**Subject:** MHI's Response to US-APWR DCD RAI No.539-4329 Revision 2

Response to Request for Additional Information  
No. 539-4329, Revision 2

**RAI NO.:** NO.539-4329 REVISION 2  
**SRP SECTION:** 09.04.02 – SPENT FUEL POOL AREA VENTILATION SYSTEM  
**APPLICATION SECTION:** Tier 2 DCD FSAR Sections 9.4.2 & 9.4.3  
**DATE OF RAI ISSUE:** 03/02/2010

Figure 9.4.3-1 Auxiliary Building HVAC System Flow Diagram (Markup)

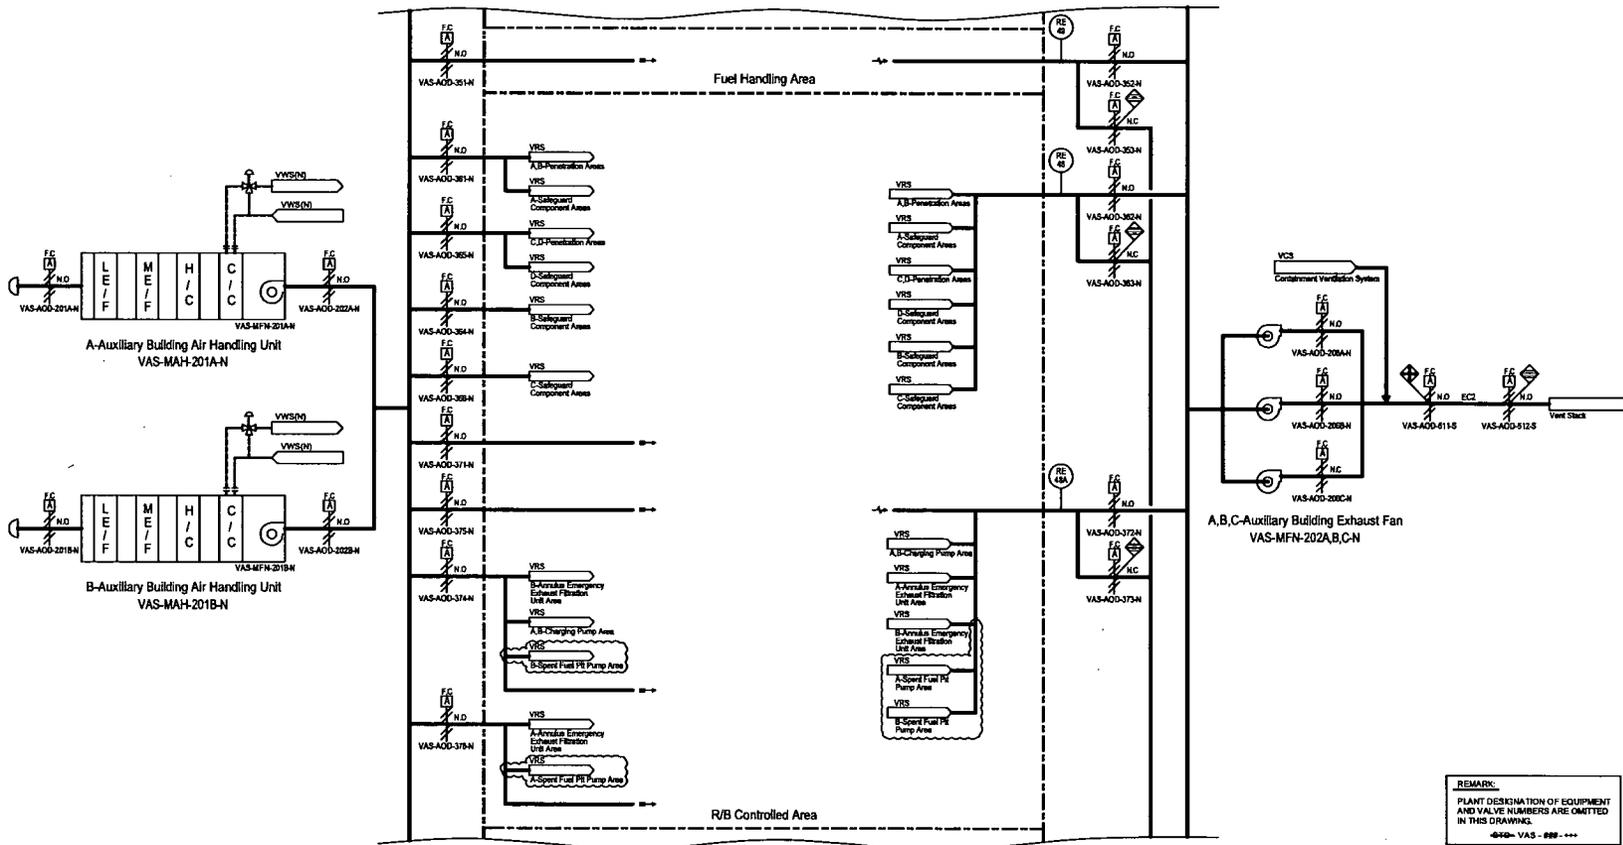
1) Figure 9.4.3-1 has not been revised to reflect that the SFP Pump and HX rooms, as displayed in Figures 1.2-16 and 1.2-24, are not part of the "fuel handling area." These areas are part of the R/B controlled area and are serviced by the A/B HVAC system during normal mode of operation. The R/B controlled area as displayed on this figure should be revised to reflect the existence of the SFP Pump and HX rooms.

- 1) Figure 9.4.3-1 is revised to reflect the existence of the SFP Pump Areas.
- 2) DCD section 9.4.3.2.1 is revised to consistent with the response to RAI No.328-2436 Revision 1 Question 09.04.02-2.
- 3) The airflow rate (i.e. Zone V to VI: 1,500 cfm; Radiation Zone IV: 14,000 cfm; and Radiation Zone III : 76,000 cfm.) shown in Table 12.2-60 Sheet 3 of 3 of DCD Tier 2 Revision 2 is the minimum exhaust airflow rate from radiological controlled areas (RCA) that are served by the auxiliary building HVAC system. Thus, as-design exhaust airflow rate from RCA that is served by the auxiliary building HVAC system may be more than the airflow rate shown in Table 12.2-60 Sheet 3 of 3. Meanwhile, the supply airflow to RCA is designed to be less than the exhaust airflow rate and to maintain a slightly negative pressure in the controlled areas with respect to outdoor environment.

Figure 9.4.3-1 will be revised as shown in 4<sup>th</sup> page.
